Gigabit Transmit Distortion Testing at UNH

Gig TX Distortion

Figure 11: Peak Distortion vs. Phase Offset

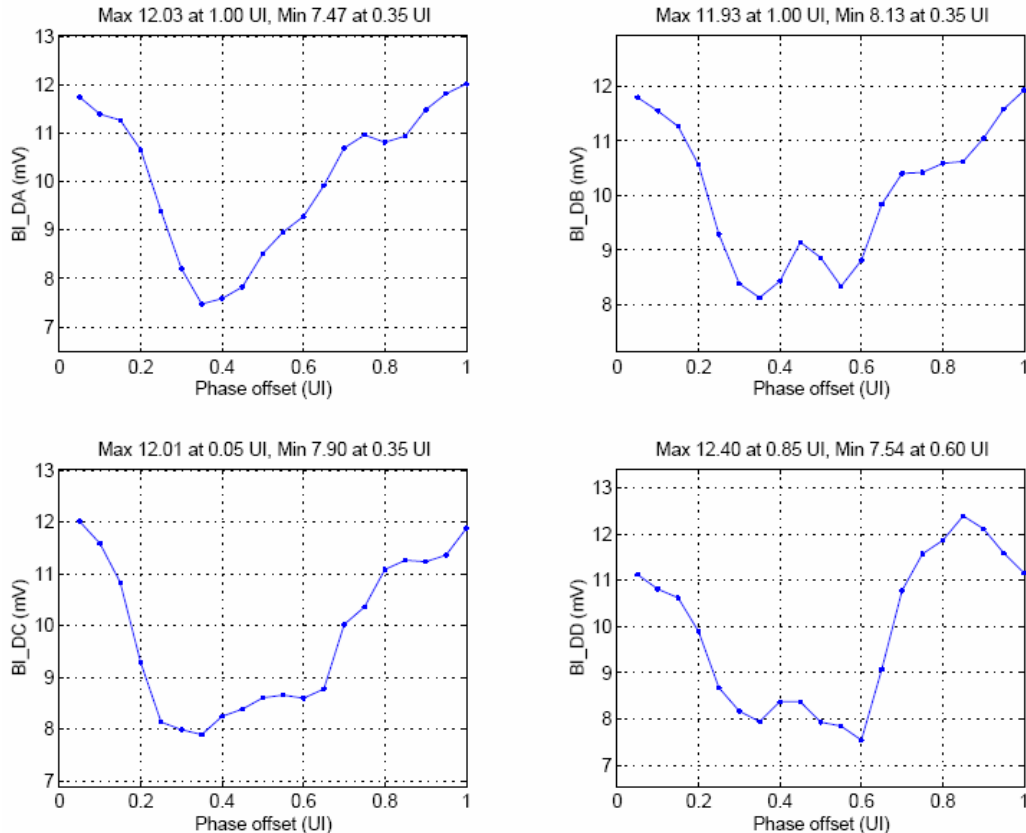
- In implementation, PHY receivers use a clock recovery to locate the widest opening of the eye diagram and sample at that point. In Cisco's UNH report on p. 16, the center of the sample period, where the widest point of the eye would exist and the PHY receiver would be trying to sample the data, Gig TX distortion is below the 10mV level.

Consistency Between Transmit Jitter and Transmit Distortion Specifications

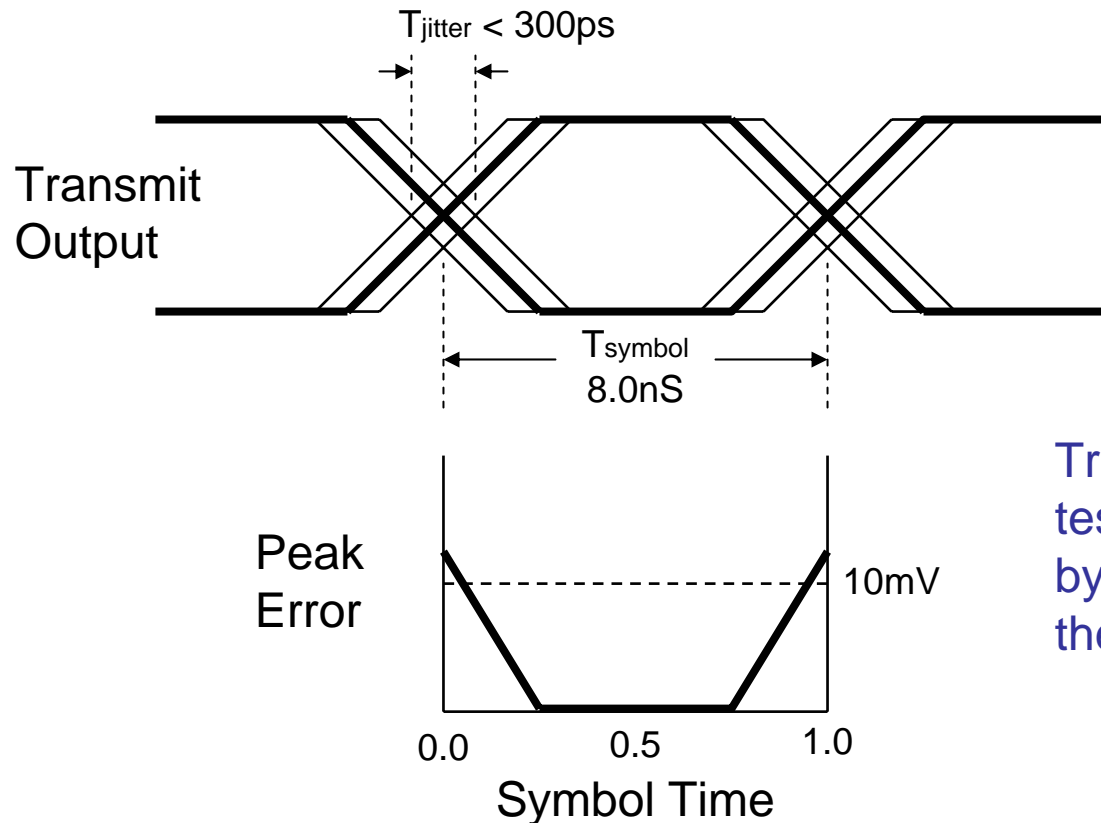
- PHY operating with allowed transmit jitter will not be able to meet 10mV distortion spec *if the distortion spec must be met at the edges*

Transmit distortion test not impacted ✓✓ by transmit jitter in the eye opening

Example: Peak Error w/ Linear Rise/Fall Time

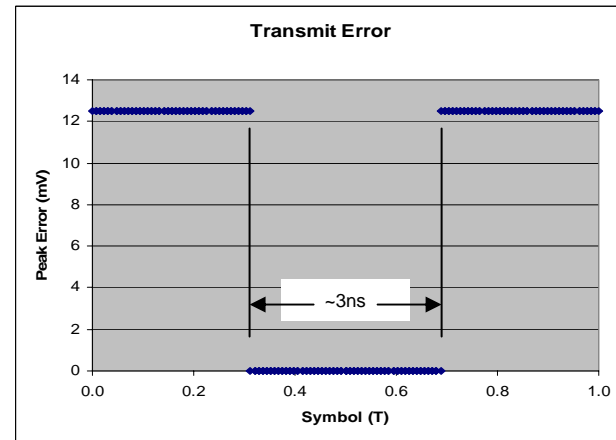
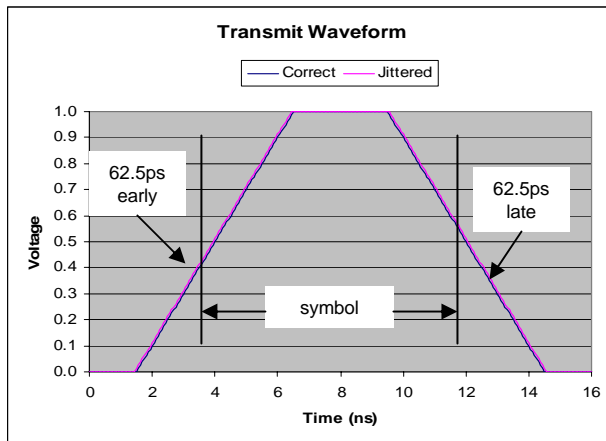
- Maximum step change of transmit output = 1.0V differential
- Rate of change = 1V/5ns at symbol transition
- Jitter per edge = 125ps / 2 = 62.5ps (clause 40.6 allows for 300ps)
- Peak error = $62.5\text{ps} / 5\text{ns} * 1.0\text{V} = 12.5\text{mV}$

**The peak error due to jitter at the edge of a symbol can exceed 12.5mV
Peak error should be measured at opening of eye
(i.e. near center of symbol).**
